SUNLIGHT HOUSE
DESIGN AND ACCESS STATEMENT
OFFICE REFURBISHMENT
140958/LO/2024

This document is a follow up to the submitted Listed Building Application for the office refurbishment at Sunlight House, Manchester, M3 3HP.

This LBC application only relates to Floors 1 & 6, previously occupied areas, the proposal follows the same principles set out in the previous application for all other floors.

LEVEL 1 FLOORING CONDITION SURVEY

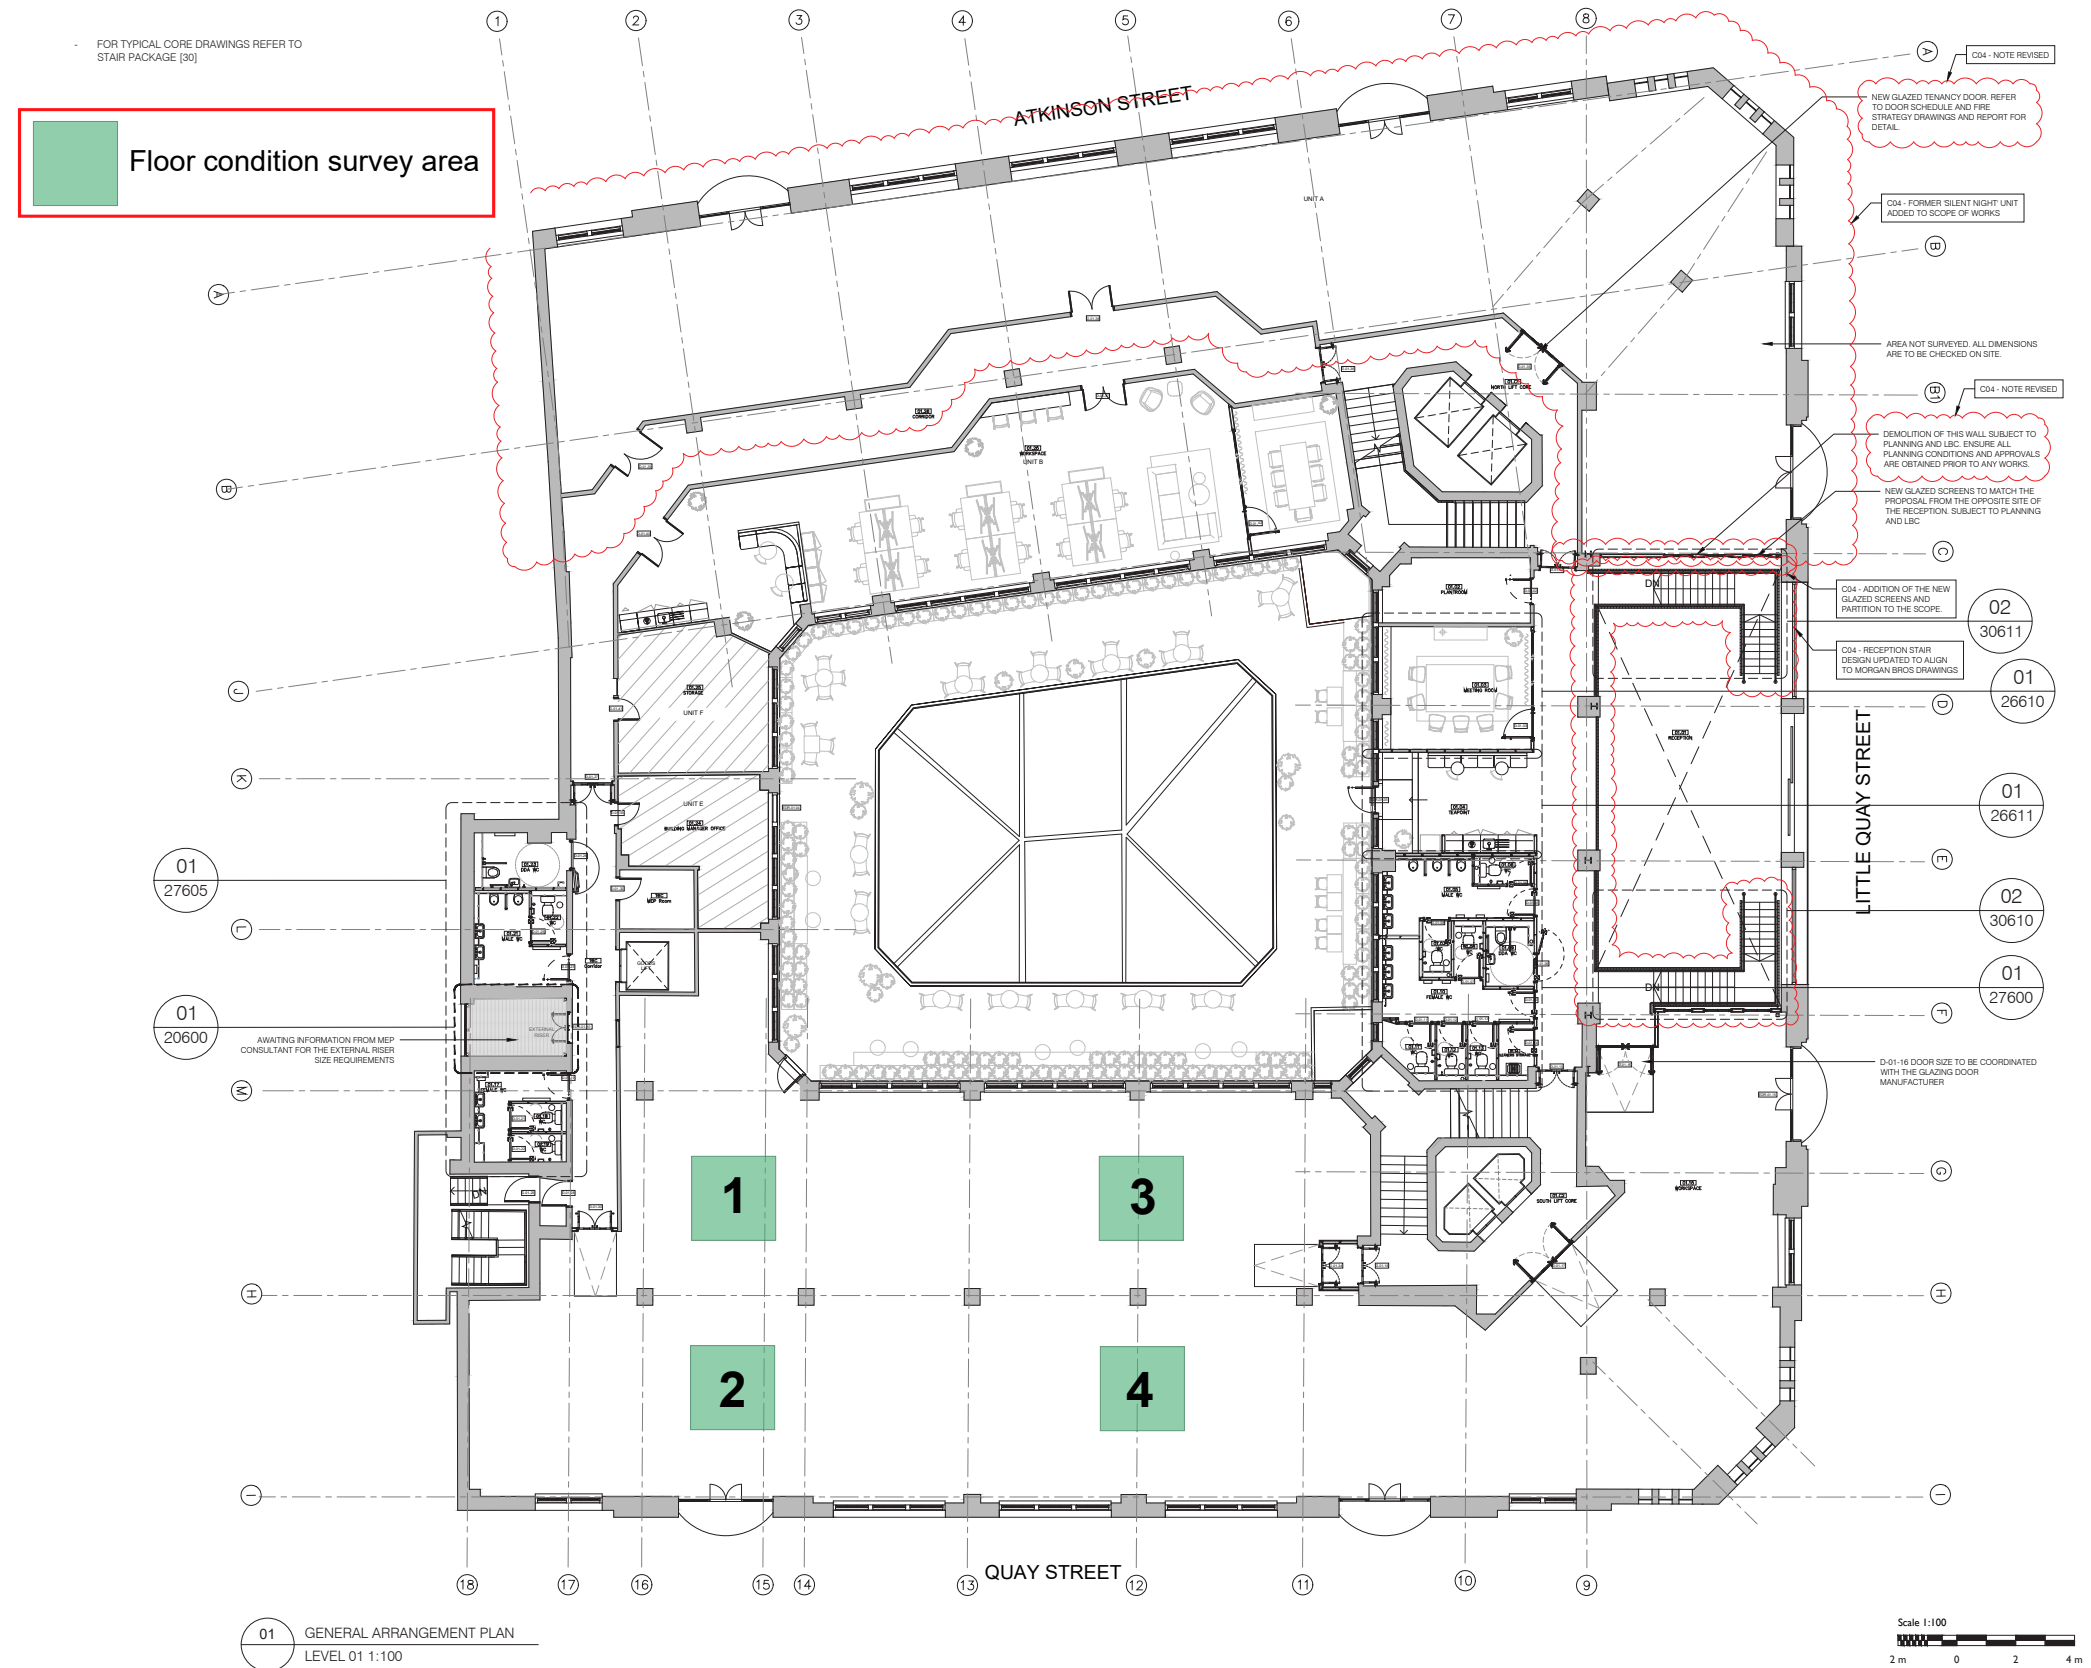
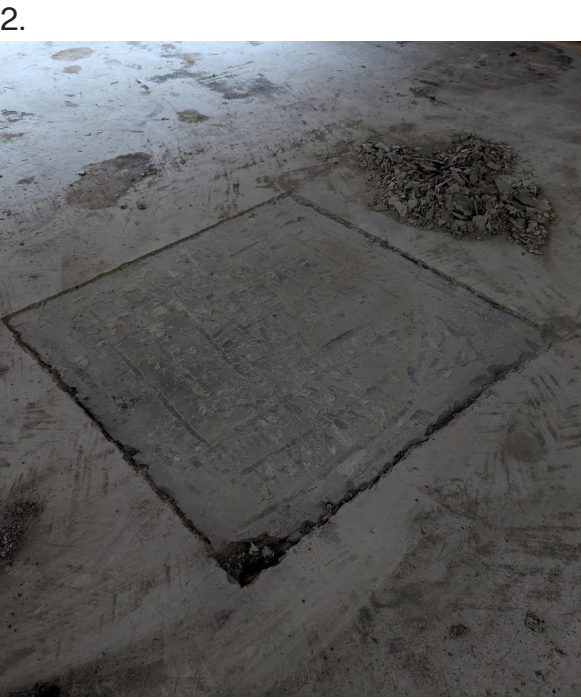
Early investigations show that in many places within the Quay Street side unit the timber is damaged badly or covered in significant screed that may result in a difficult and unviable process. It is proposed to instal raised access floor in this unit.

Unit on the Atkindon Street side is proposed to have refurbished parquet floor.

LEVEL 6 FLOORING CONDITION SURVEY

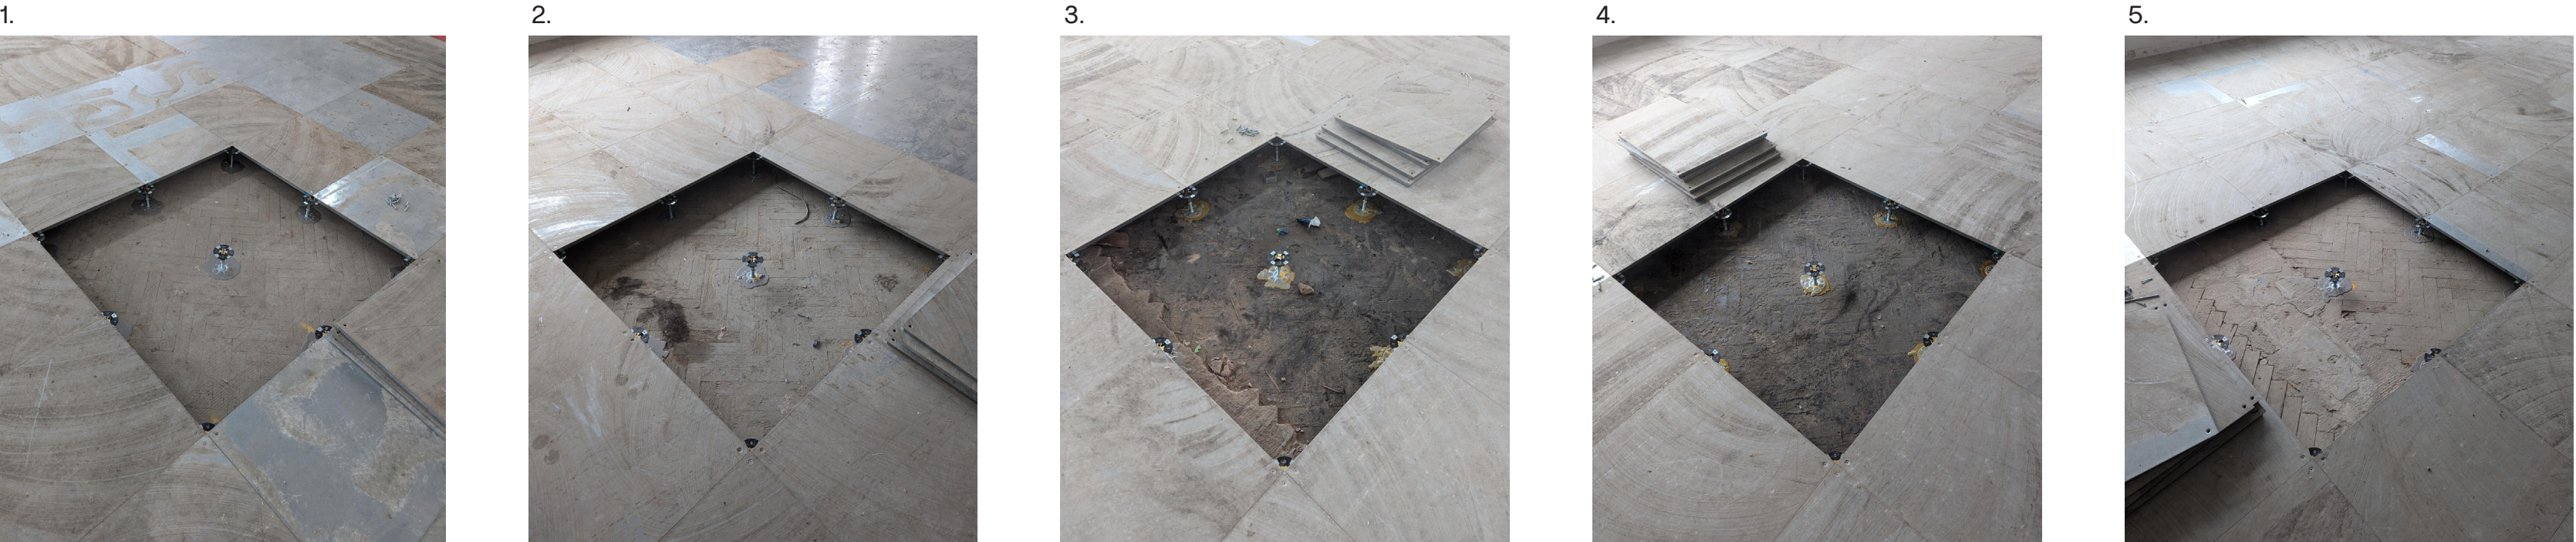
Early investigations show that parquet on Level 6 is in good condition, currently the floor is covered with raised access floor tiles. As shown on the photographs on the next page.

It is proposed the areas on Level 6 covered by this application to have exposed refurbished parquet floor.

LEVEL 1 GA RCP

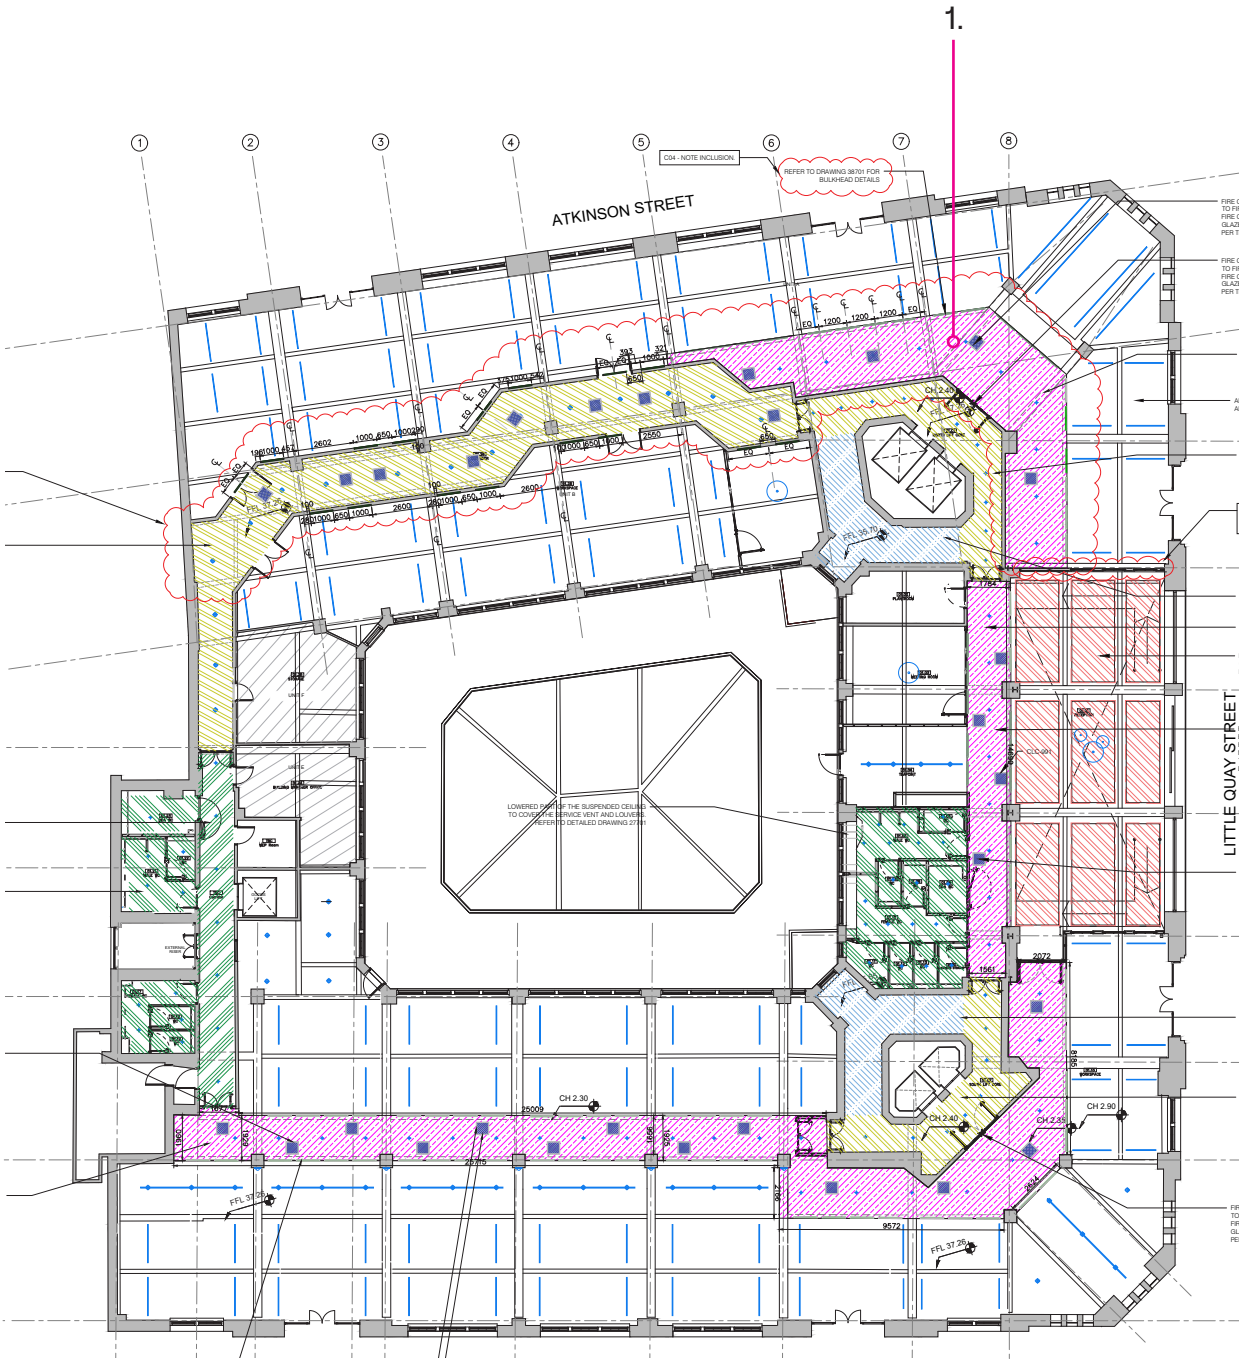
- 1. Unit on Atkinson street to be ventilated through the corridor with vents at the high level along the existing modern wall. Around the North Core to avoid penetrations to the heritage wall and routing through the fire rated Core a section of bulkhead is introduced. It follows the same bulkhead principles previously approved in this area.

LEVEL 1
WALL BETWEEN UNIT AND RECEPTION

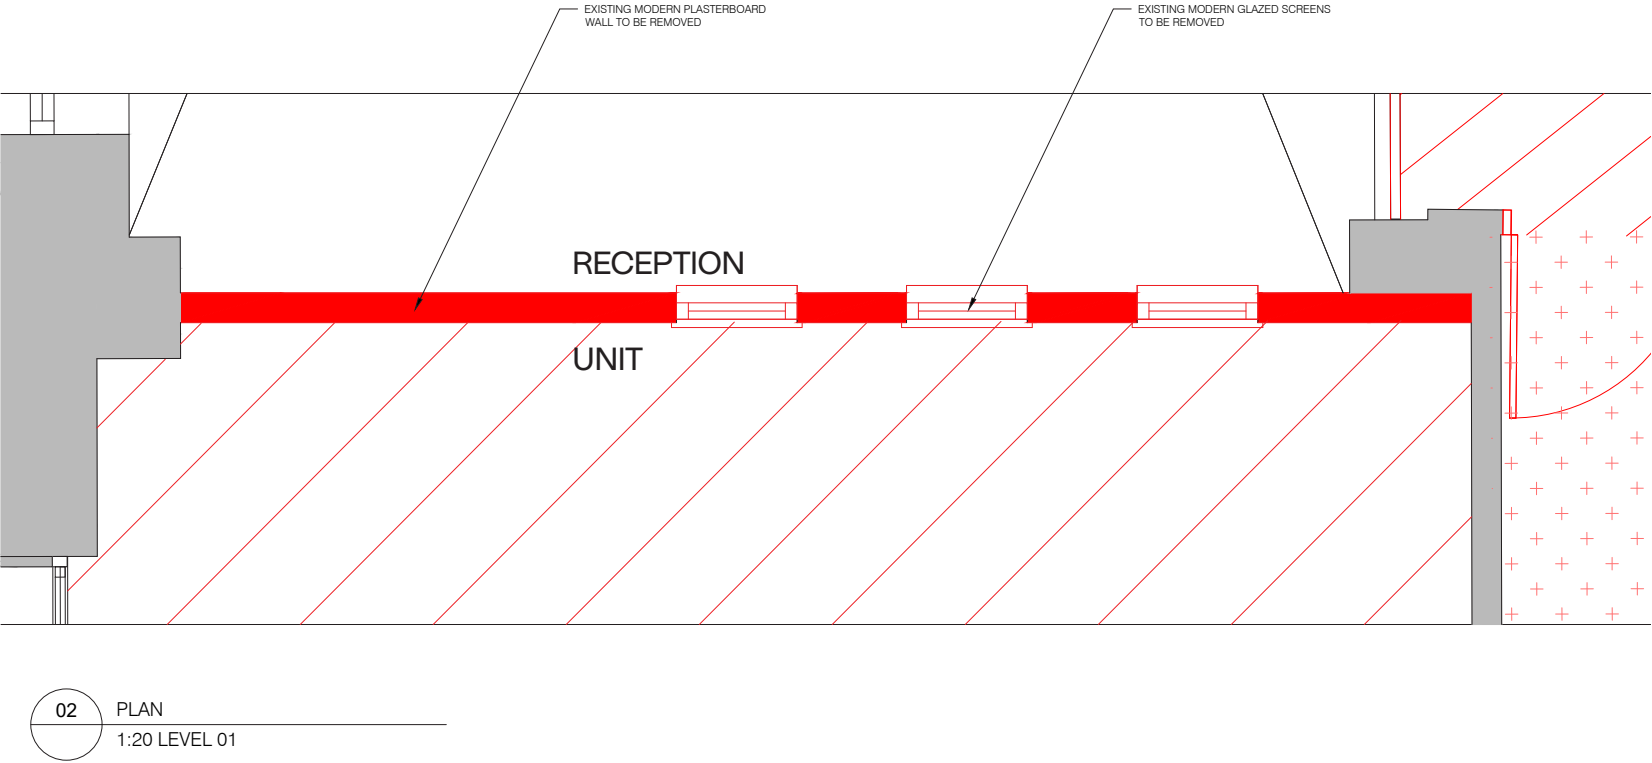
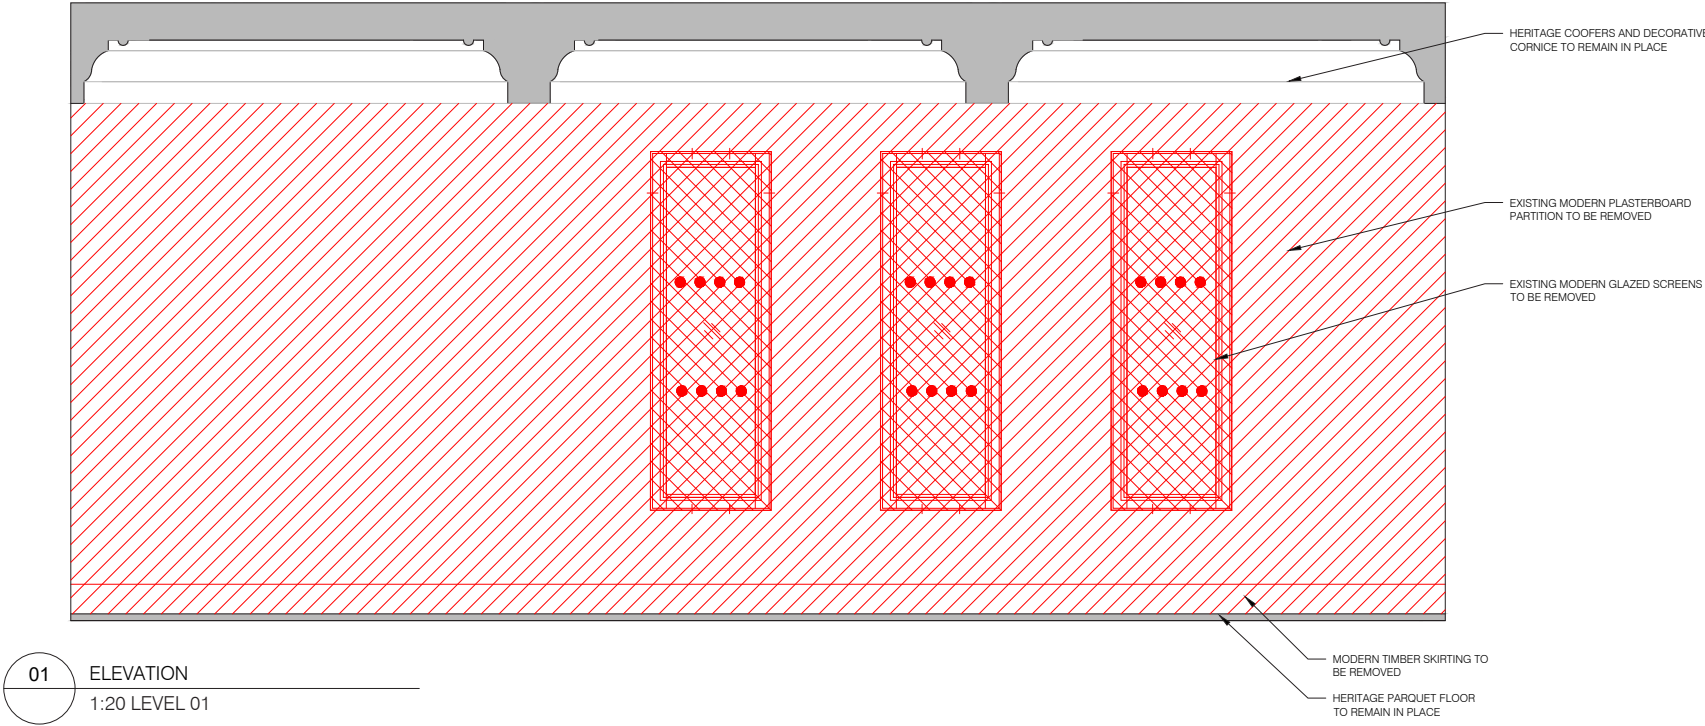
Modern plasterboard wall to be removed together with modern skirting and glazed screens. Historib cornice detail and beam to remain in situ.
